Access Compliance Report

Public Rights-of-Way

Intersection ID: 13531	Main Street: REMOUNT_RD	Cross Street: WEST_BV	Location: NE
ADA ID: 6470E25BEB7F	Ramp Type: PerpDiag	Initial Pass/Fail: Fail	Overall Compliance: No
		Severity Score: 50

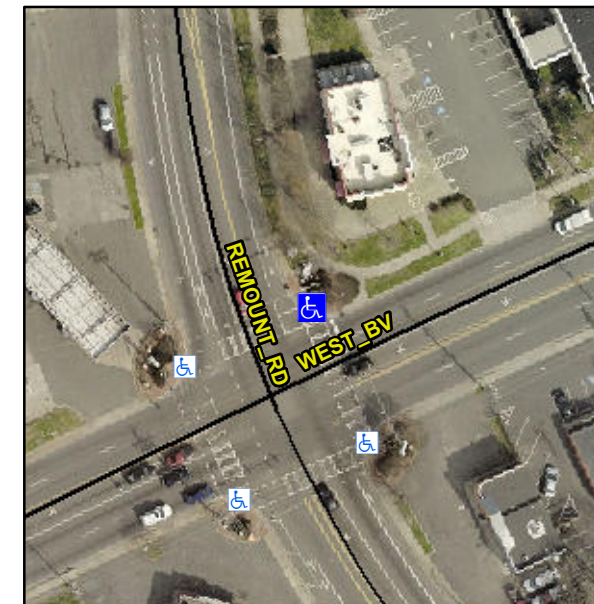
Not Found, R304.2.2, R304.5.3

Compliance	Description	Data	Compliance	Description	Data
N/A	Ramp Length (in)	67.0	No	Ramp Slope (%)	12.0
Yes	Ramp Width (in)	49.0	No	Ramp XSlope (%)	9.7
N/A	Flare Type LT	N/A	N/A	Flare Type RT	N/A
N/A	Flare Slope LT (%)	N/A	N/A	Flare Slope RT (%)	N/A
N/A	Flare Traversable LT?	N/A	N/A	Flare Traversable RT?	N/A
N/A	Landing Length (in)	N/A	N/A	DWS Provided?	N/A
N/A	Landing Width (in)	N/A	N/A	DWS Contrast?	N/A
N/A	Landing Slope (%)	N/A	N/A	DWS Length (in)	N/A
N/A	Landing X Slope (%)	N/A	N/A	DWS Full Width?	N/A
N/A	Landing Curb? (Y/N)	N/A	N/A	DWS Offset (in)	N/A
N/A	Shared Landing?	N/A			
N/A	Gutter Ponding?	N/A	N/A	Gutter Slope (%)	N/A
N/A	Gutter Lip Ht (in)	N/A	N/A	Gutter X Slope (%)	N/A
N/A	Painted X Walk1?	Yes	N/A	Painted X Walk2?	Yes
	X Walk 1 Direction	To W		X Walk 2 Direction	To S
N/A	X Walk 1 Width (in)	111.0	N/A	X Walk 2 Width (in)	110.0
	X Walk 1 Slope (%)	1.7		X Walk 2 Slope (%)	1.2
	X Walk 1 X Slope (%)	4.5		X Walk 2 X Slope (%)	3.8

Remove & Replace Curb Ramp With Two New Directional Ramps or Equivalent.
